Access Compliance Report

Public Rights-of-Way

Intersection ID: 12164	Main Street: SEIGLE_AV	Cross Street: BELMONT_AV	Location: W
ADA ID: B26865DF6403	Ramp Type: Perp	Initial Pass/Fail: Fail	Overall Compliance: No
Severity Score: 12.5			
Codes/Mitigation Info/Possible Solution		Field Measurements/Component Compliance

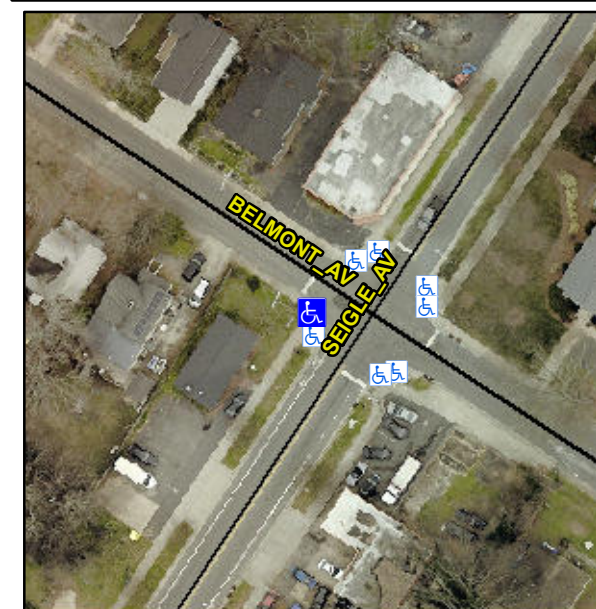
Not Found, R304.5.3

Compliance	Description	Data	Compliance	Description	Data
N/A	Ramp Length (in)	56.0	Yes	Ramp Slope (%)	6.4
Yes	Ramp Width (in)	48.0	No	Ramp XSlope (%)	5.2
N/A	Flare Type LT	N/A	N/A	Flare Type RT	N/A
N/A	Flare Slope LT (%)	N/A	N/A	Flare Slope RT (%)	N/A
N/A	Flare Traversable LT?	N/A	N/A	Flare Traversable RT?	N/A
N/A	Landing Length (in)	N/A	N/A	DWS Provided?	N/A
N/A	Landing Width (in)	N/A	N/A	DWS Contrast?	N/A
N/A	Landing Slope (%)	N/A	N/A	DWS Length (in)	N/A
N/A	Landing X Slope (%)	N/A	N/A	DWS Full Width?	N/A
N/A	Landing Curb? (Y/N)	N/A	N/A	DWS Offset (in)	N/A
N/A	Shared Landing?	N/A			
N/A	Gutter Ponding?	N/A	N/A	Gutter Slope (%)	N/A
N/A	Gutter Lip Ht (in)	N/A	N/A	Gutter X Slope (%)	N/A
N/A	Painted X Walk1?	No	N/A	Painted X Walk2?	N/A
	X Walk 1 Direction	To NE		X Walk 2 Direction	N/A
N/A	X Walk 1 Width (in)	N/A	N/A	X Walk 2 Width (in)	N/A
	X Walk 1 Slope (%)	4.7		X Walk 2 Slope (%)	N/A
	X Walk 1 X Slope (%)	8.5		X Walk 2 X Slope (%)	N/A

Remove & Replace Entire Ramp.
